# Access Compliance Report

## Public Rights-of-Way

### (Curb Ramps)

Intersection ID: 6073	Main Street: SUTHER_RD	Cross Street: VINCA_CR	Location:	N
ADA ID: 0DAE69411D23	Ramp Type: Perp	Initial Pass/Fail: Fail	Overall Compliance: No	Severity Score: 50

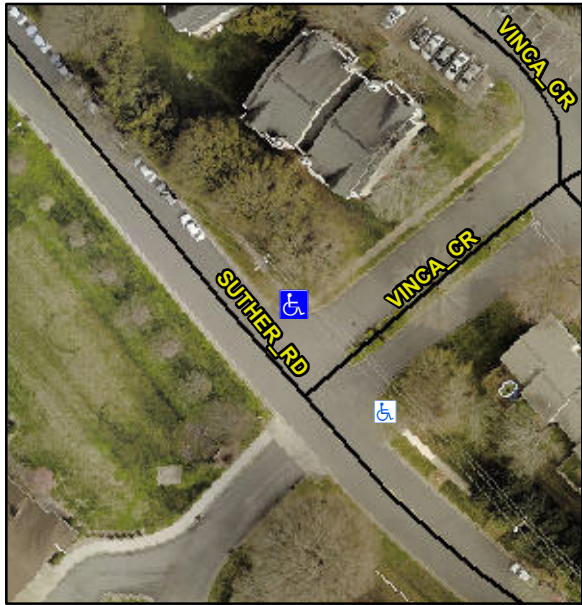
Codes/Mitigation Info/Possible Solution			Field Measurements/Component Compliance					
 <div>Street 1 NameVINCA CR</div> <div>Stop Condition-Street 2StopSign</div> <div>Street 2 NameN/A</div> <div>Stop Condition-Street 1N/A</div>	Possible Solutions:		Compliance			Compliance		
	Remove & Replace Entire Ramp.		N/A	Ramp Length (in)	52.0	No	Ramp Slope (%)	13.8
			Yes	Ramp Width (in)	48.0	No	Ramp XSlope (%)	8.0
			N/A	Flare Type LT	N/A	N/A	Flare Type RT	N/A
			N/A	Flare Slope LT (%)	N/A	N/A	Flare Slope RT (%)	N/A
			N/A	Flare Traversable LT?	N/A	N/A	Flare Traversable RT?	N/A
			N/A	Landing Length (in)	N/A	N/A	DWS Provided?	N/A
			N/A	Landing Width (in)	N/A	N/A	DWS Contrast?	N/A
			N/A	Landing Slope (%)	N/A	N/A	DWS Length (in)	N/A
			N/A	Landing X Slope (%)	N/A	N/A	DWS Full Width?	N/A
Surveyor Notes:		N/A	N/A	Landing Curb? (Y/N)	N/A	N/A	DWS Offset (in)	N/A
PROW/ADA:		Not Found, R304.2.2, R304.5.3	N/A	Shared Landing?	N/A
